Tuesday, August 11, 2020
Medway Planning and Economic Development Board
155 Village Street
Medway, MA 02053

MEDWAY MILL SITE PLAN PUBLIC HEARING:

Medway Mill Site Plan Public Hearing

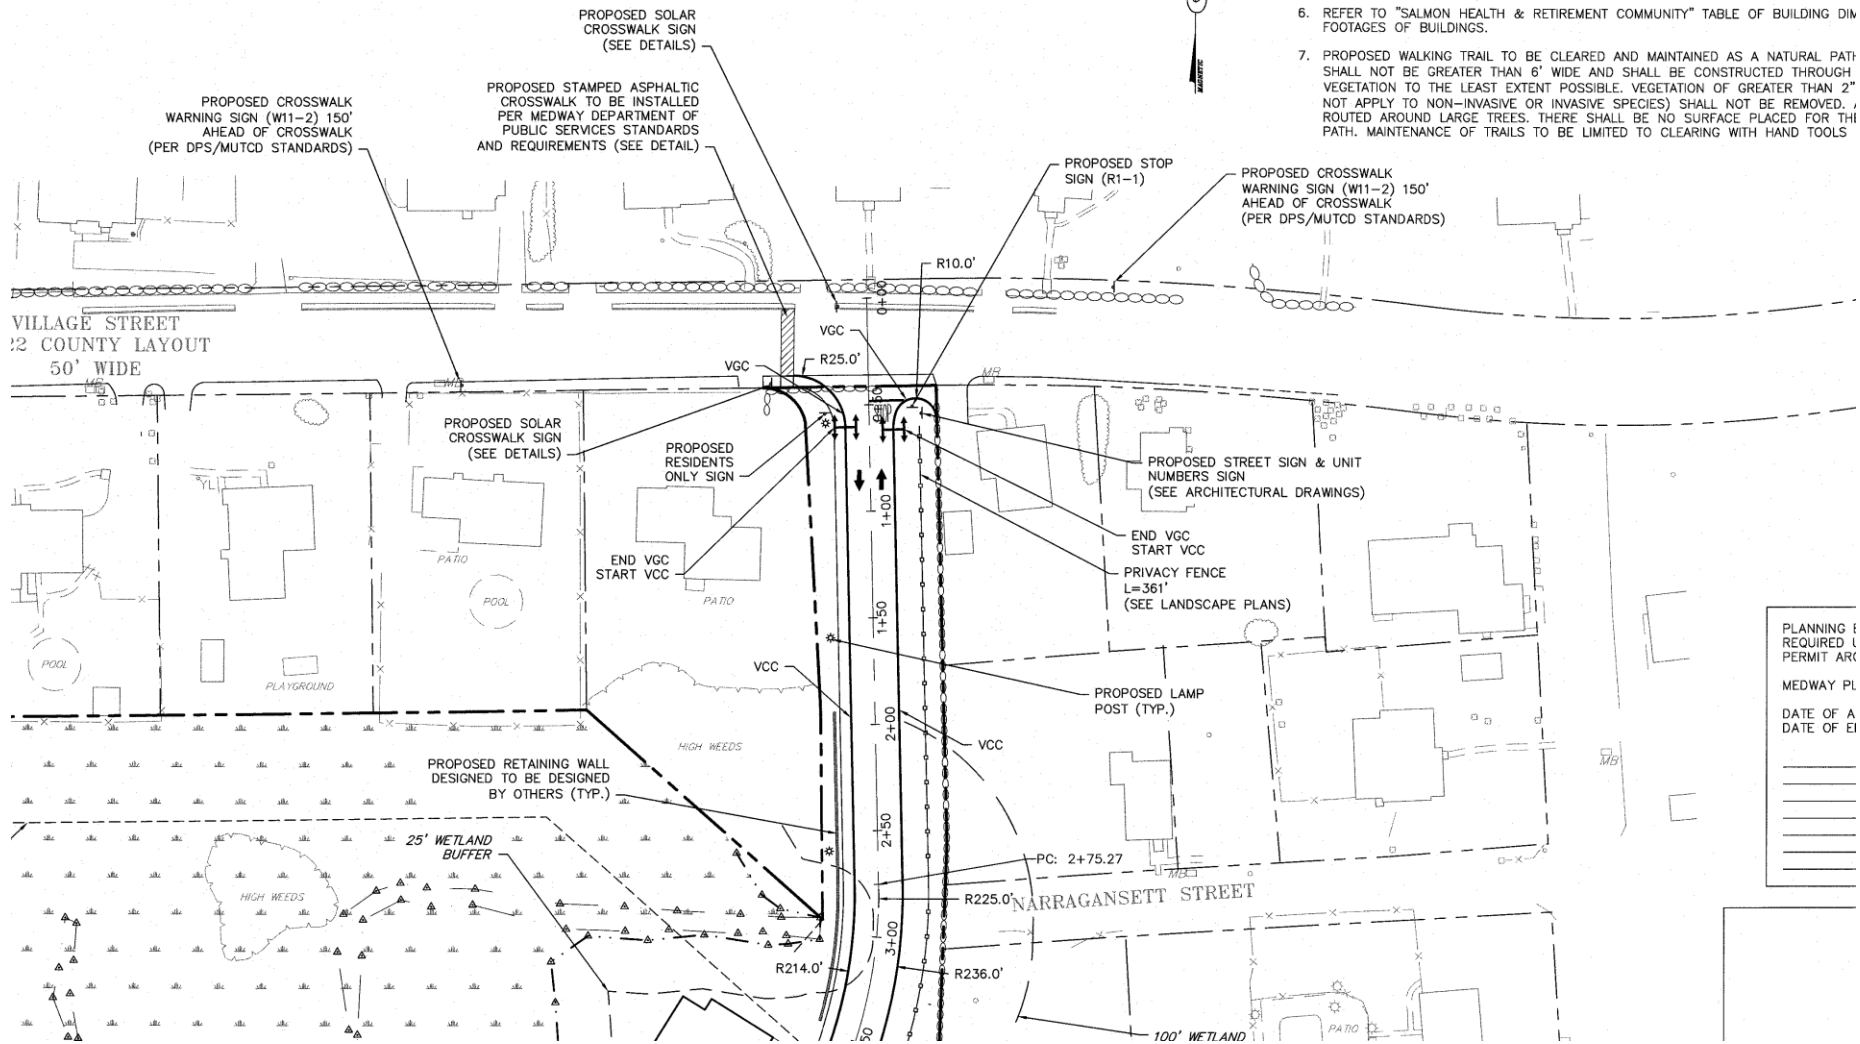
the red line is our
property and was
removed without have
any from of a
conversation with us.

We were asked to send
in our idea for the
connection of our drive
way and waterside run

Member Tucker wanted to know why the curb is set so far back. It should be consistent with the street line. It was suggested that the arc of the curbing could start at the property line. Consultant Bouley will follow up with Coneco. The developer will address having the flare at the end and made consistent with the existing street line. The grading should also be looked at. There should also be granite curbing at the entrance. There will be fencing on both sides and the fencing is a PVC material. It slopes downward to not block sight lines for exiting traffic from Waterside Run. The fence will be installed behind the curb. This can be handled as a field change. Mr. Robinson is amenable to this change and will direct his engineering firm to provide a drawing.

**PROPOSED CONDITIONS
VIEW ON WEST SIDE OF CHICKEN
BROOK TOWARDS MAIN STREET**

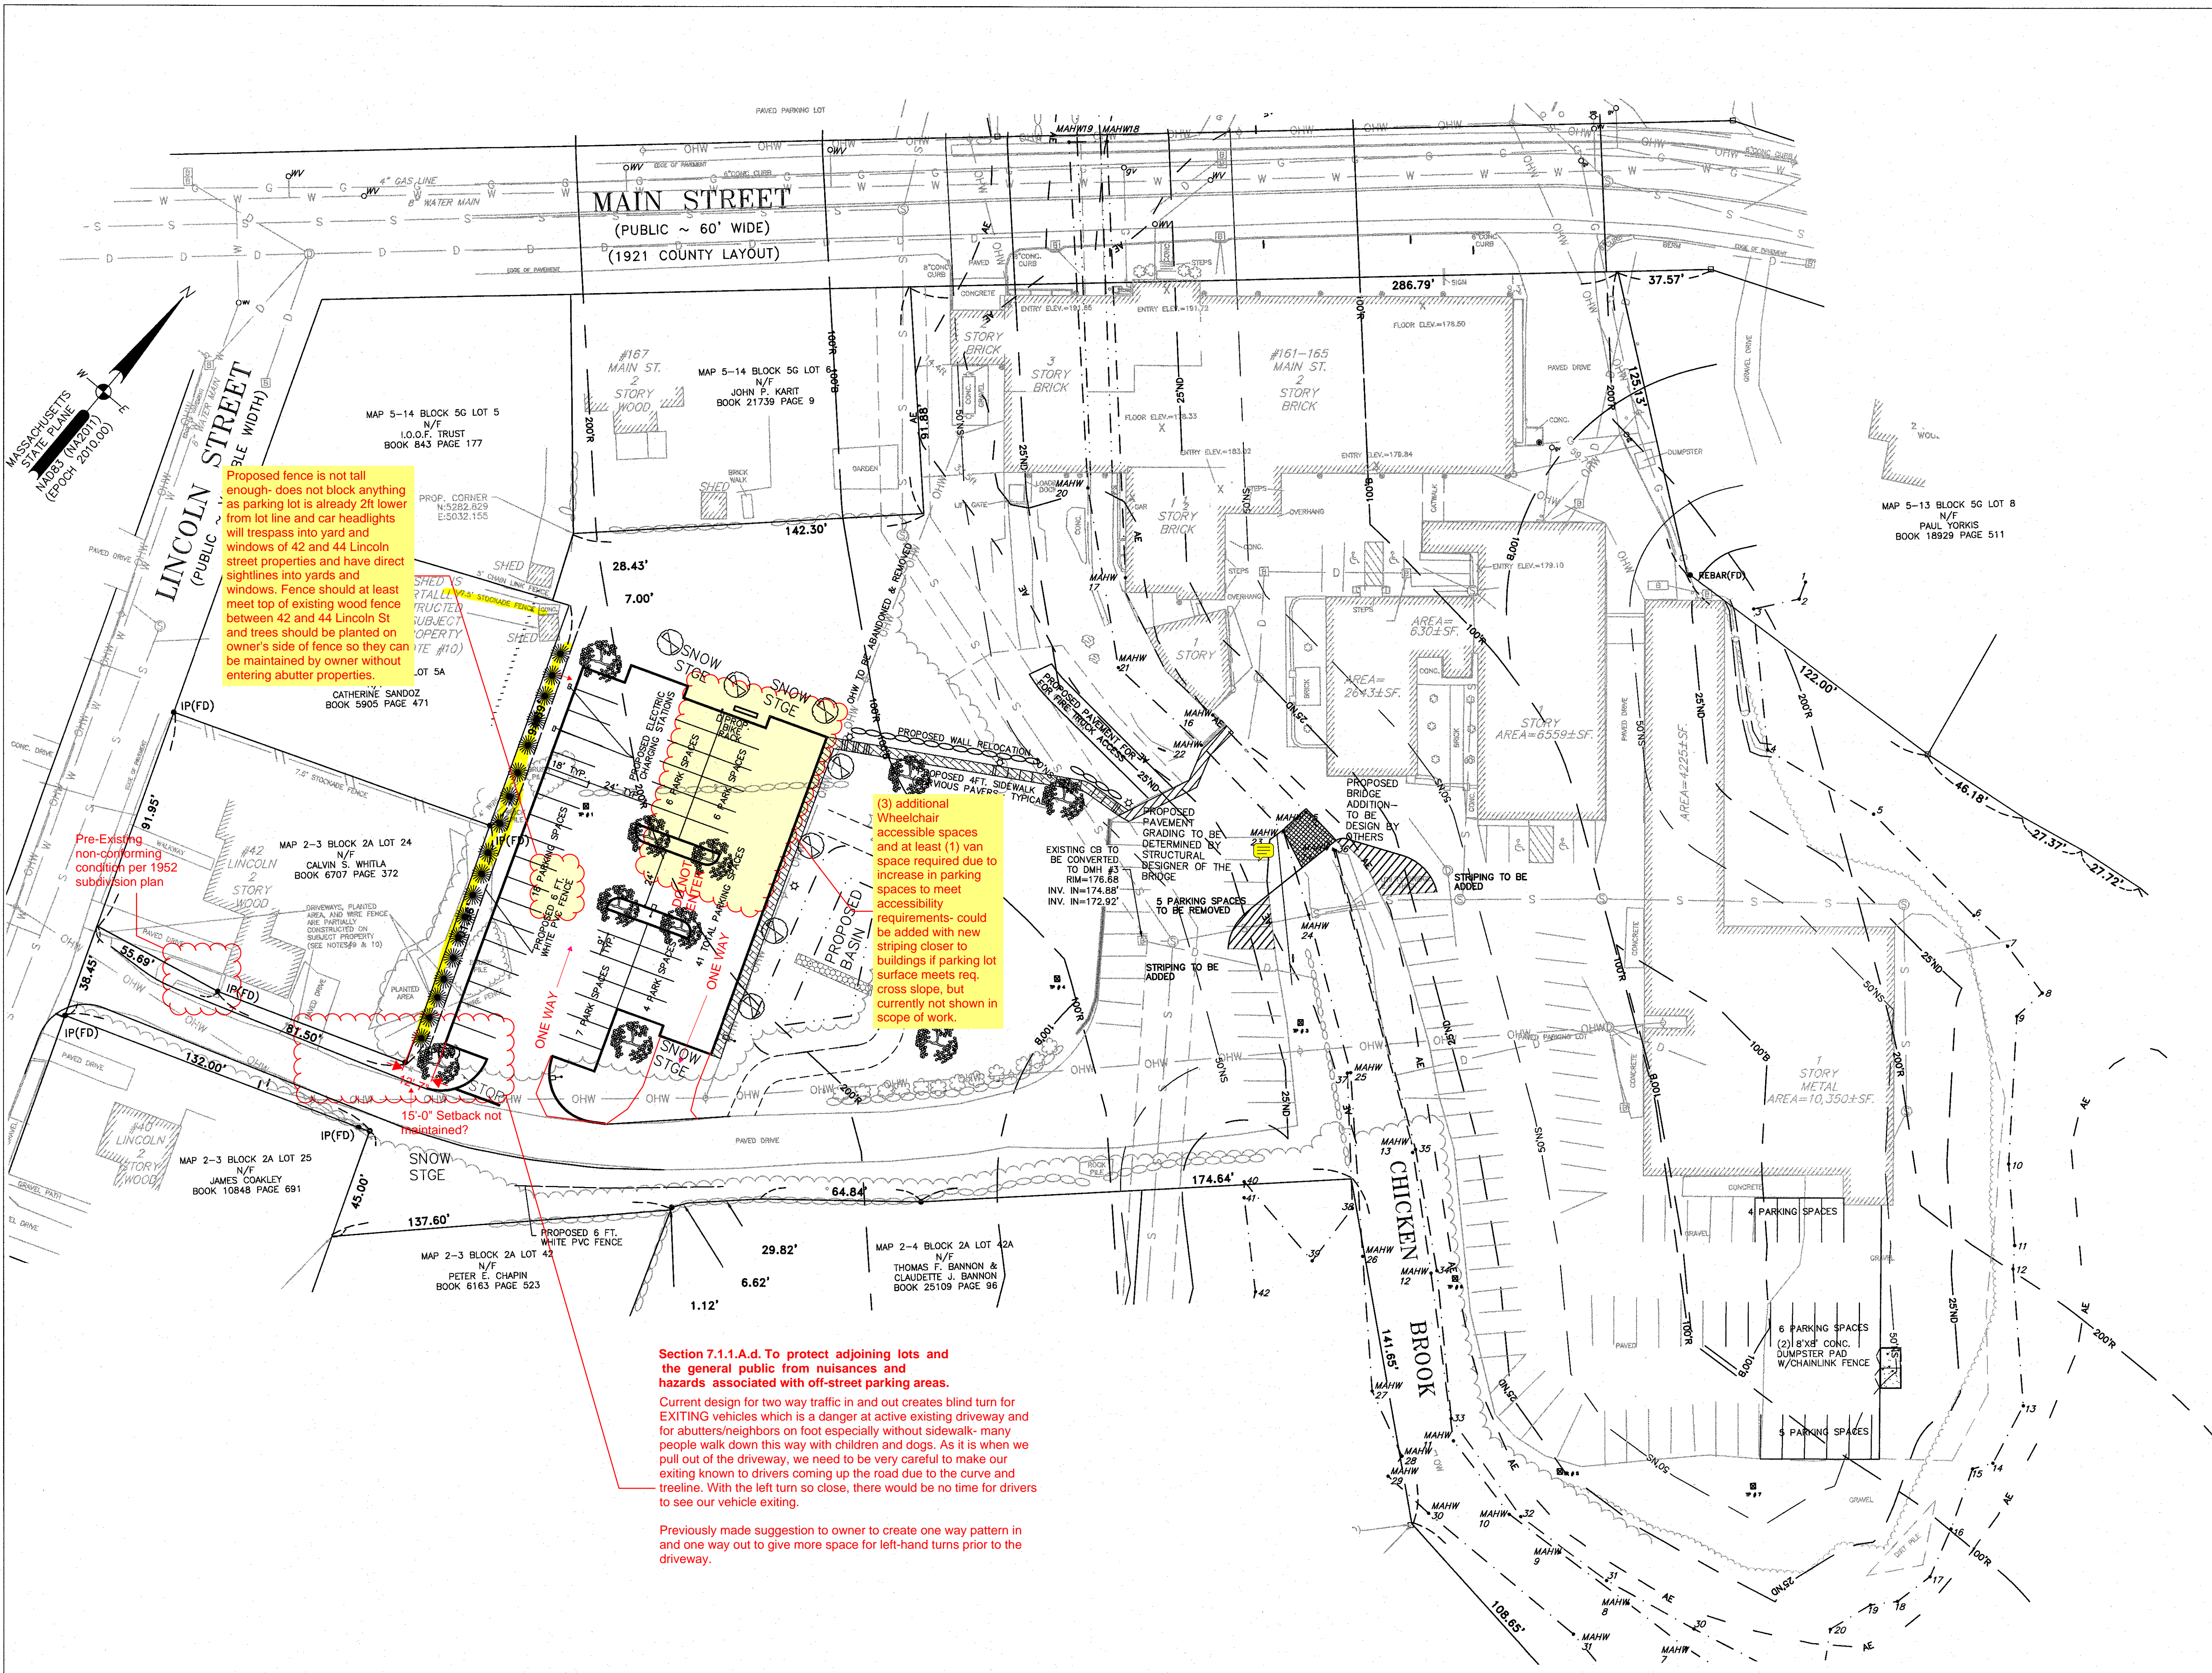
Proposed fence is not tall enough- does not block anything as parking lot is already 2ft lower from lot line and car headlights will trespass into yard and windows of 42 and 44 Lincoln street properties and have direct sightlines into yards and windows. Fence should at least meet top of existing wood fence between 42 and 44 Lincoln St and trees should be planted on owner's side of fence so they can be maintained by owner without entering abutter properties.

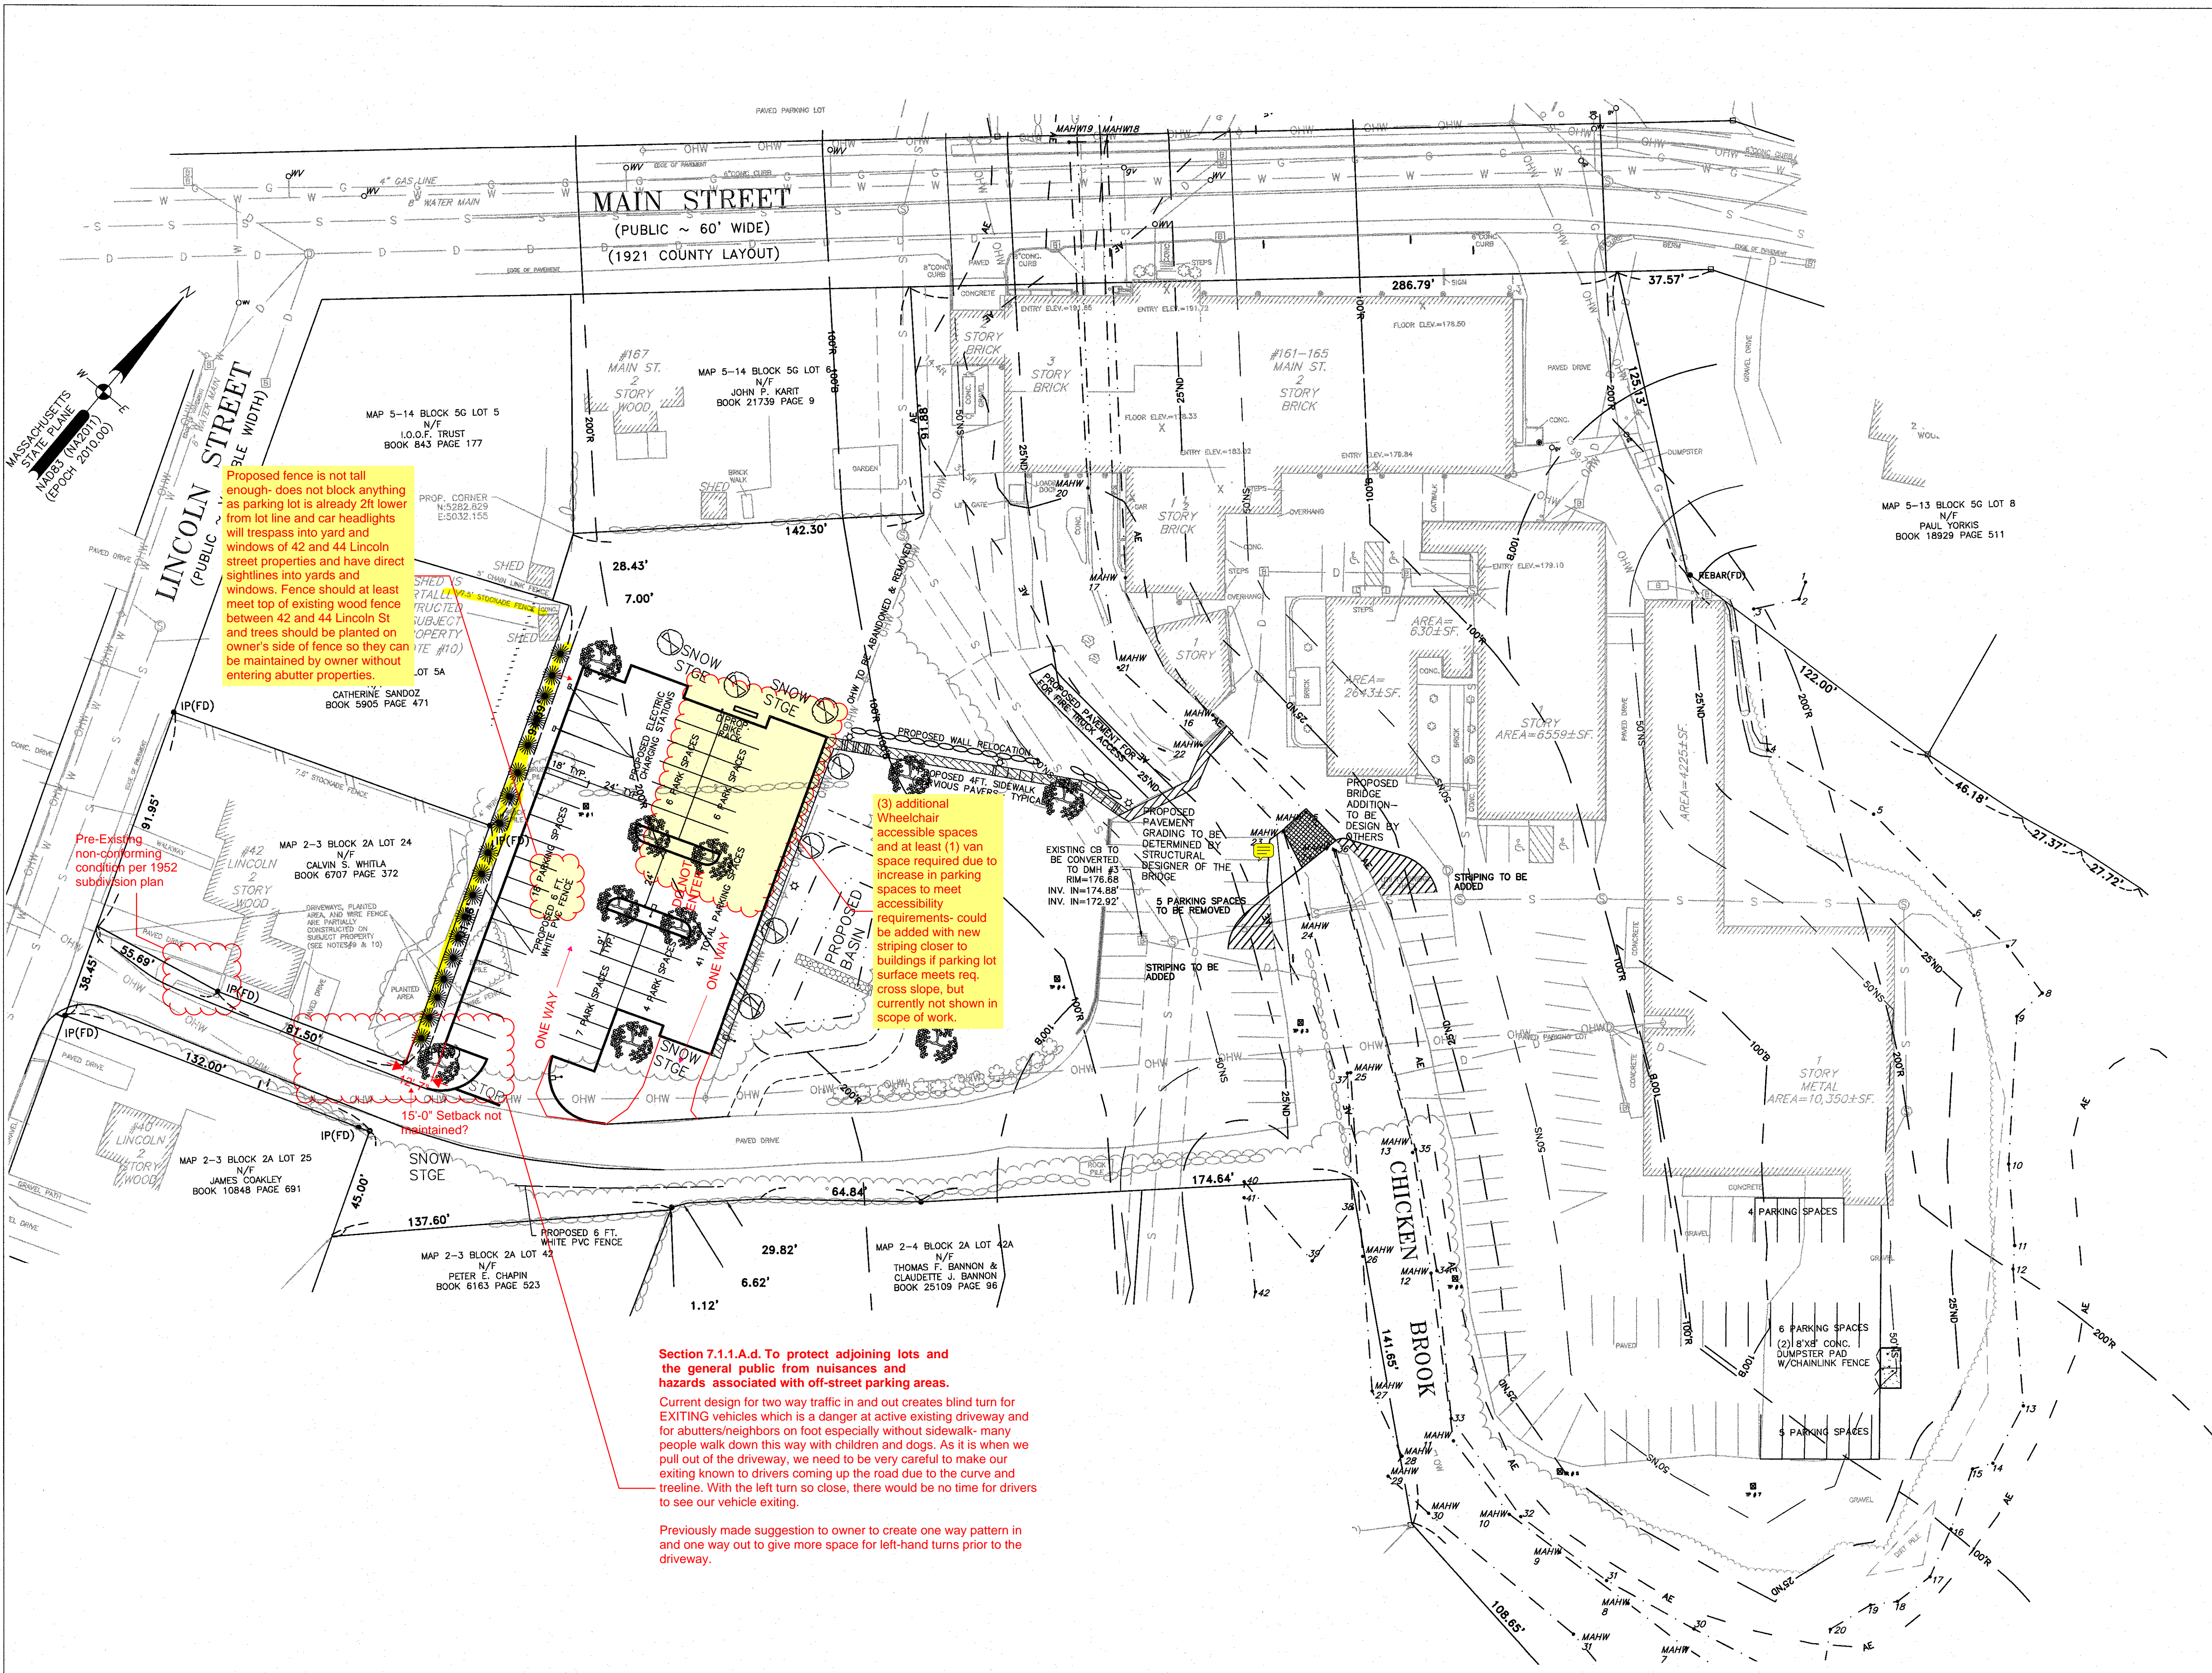
Proposed fence is not tall enough- does not block anything as parking lot is already 2ft lower from lot line and car headlights will trespass into yard and windows of 42 and 44 Lincoln street properties and have direct sightlines into yards and windows. Fence should at least meet top of existing wood fence between 42 and 44 Lincoln St and trees should be planted on owner's side of fence so they can be maintained by owner without entering abutter properties.
